Great Lakes UK Limited
Great Wolf Lodge, Chesterton, Bicester

Non Material Amendment (S.96a) Application
Design Changes

March 2023

Proposed Amended Scheme - South-East Elevation

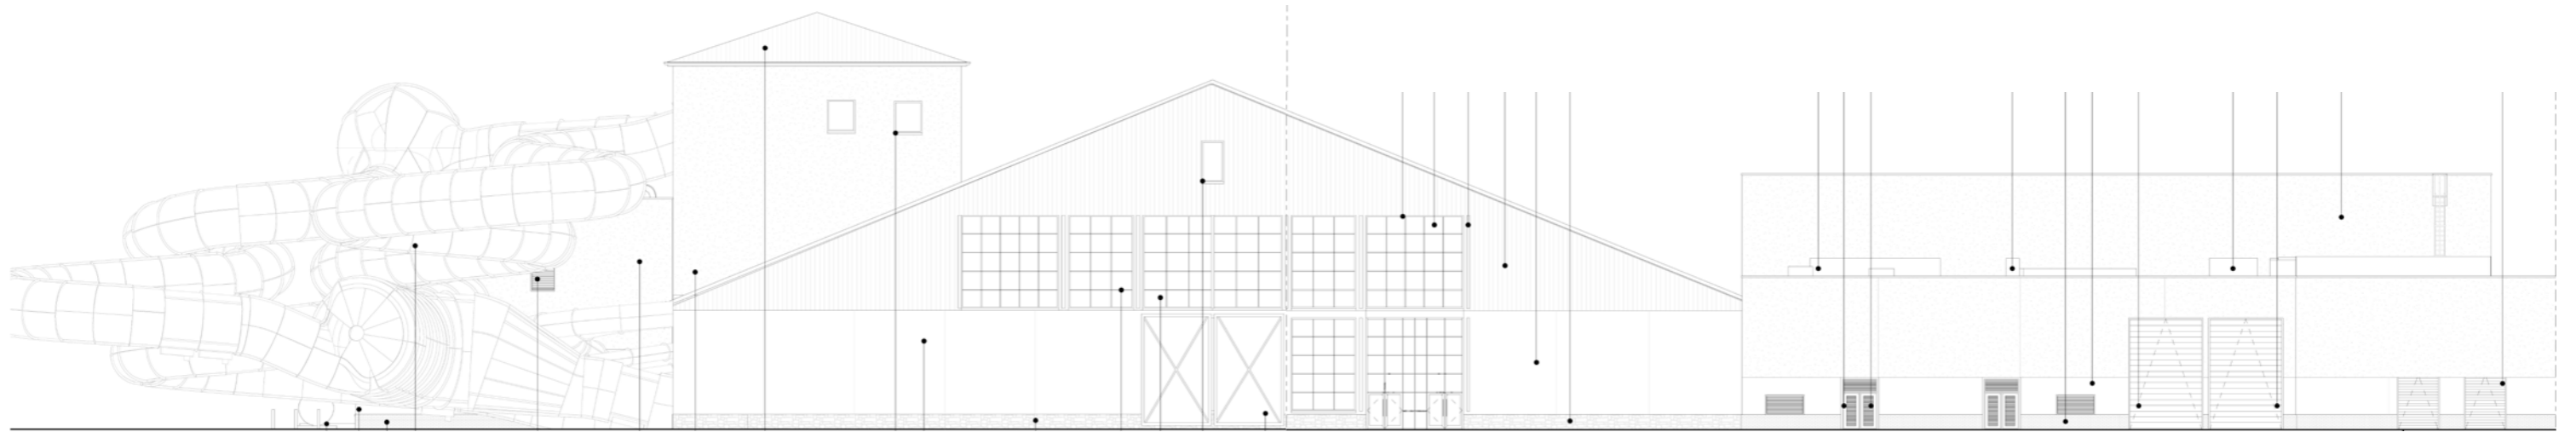
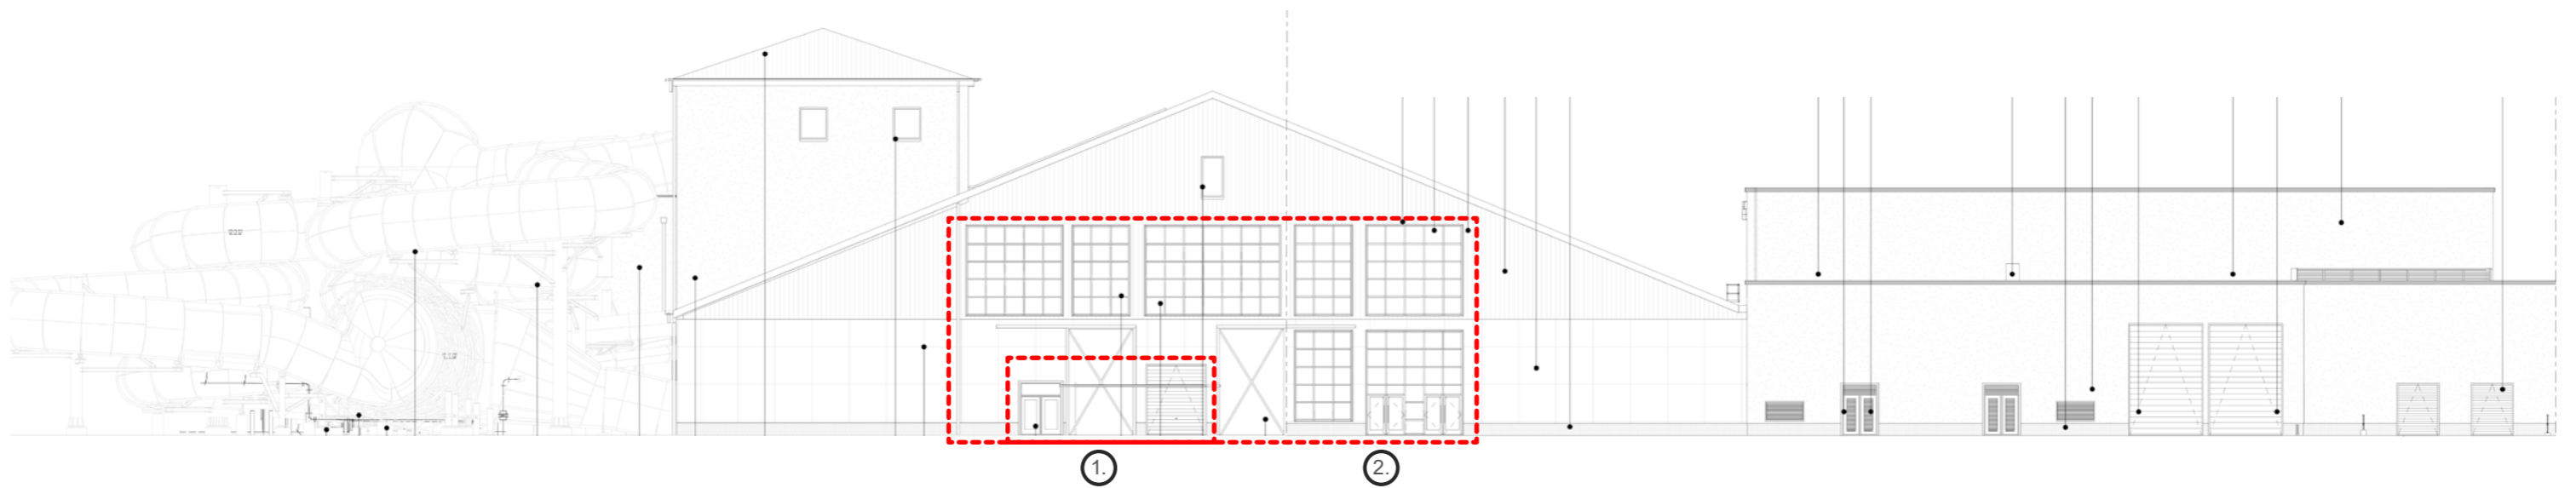
- ① Roller shutter door move and fire escape door moved to south east elevation.
- ② Omission of brise soleil from south eastern gable elevation of waterpark.

Proposed Amended Scheme - North-East Elevation

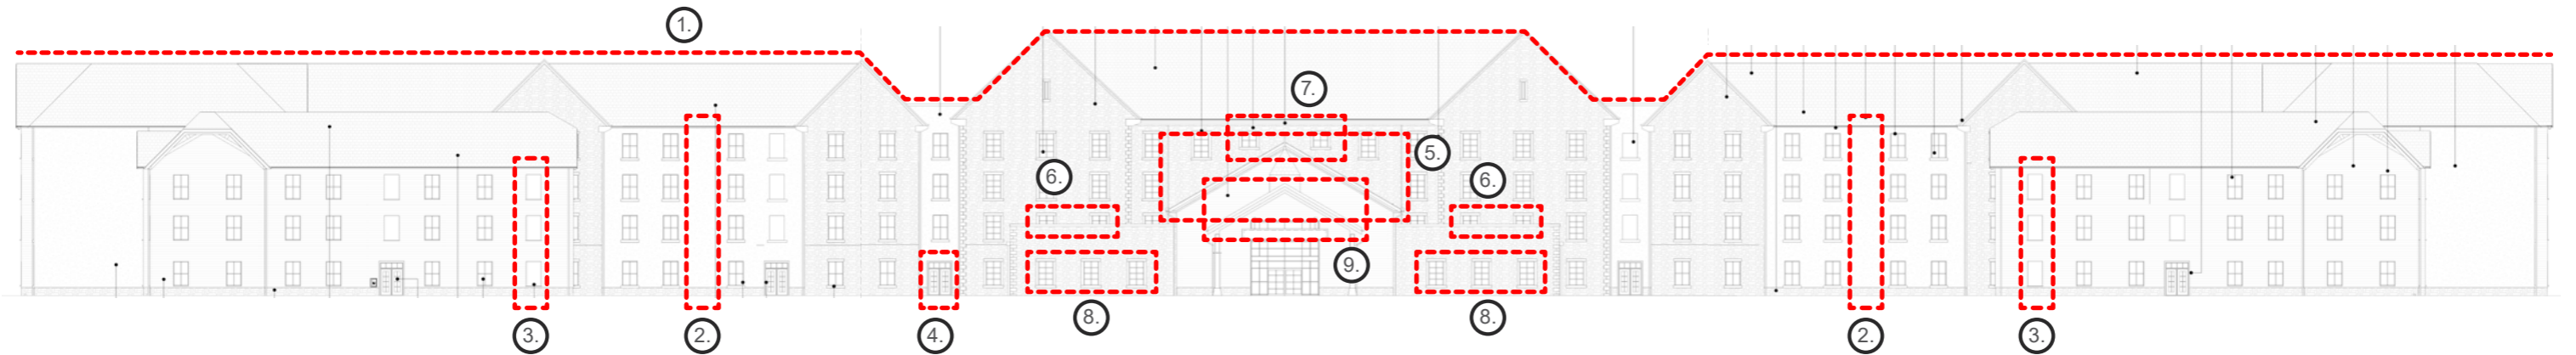
- ① **Reduced** the overall height of the hotel tower.
- ② Moving the RWP on NE elevation.
- ③ Replace windows in corner rooms (where there were two windows in room) to recessed reveal detail.
- ④ Door to ground floor added for fire escape.
- ⑤ Roof above hotel lobby lowered by approx. 990mm as part of improved building efficiency.
- ⑥ Window types on the east side updated to match those on west side.
- ⑦ Window heights and sill height updated to avoid clash with roof line and weathering required.
- ⑧ Changes to ground floor window heights to match adjacent elevations.
- ⑨ Small increase in height to Porte Cochere roof.
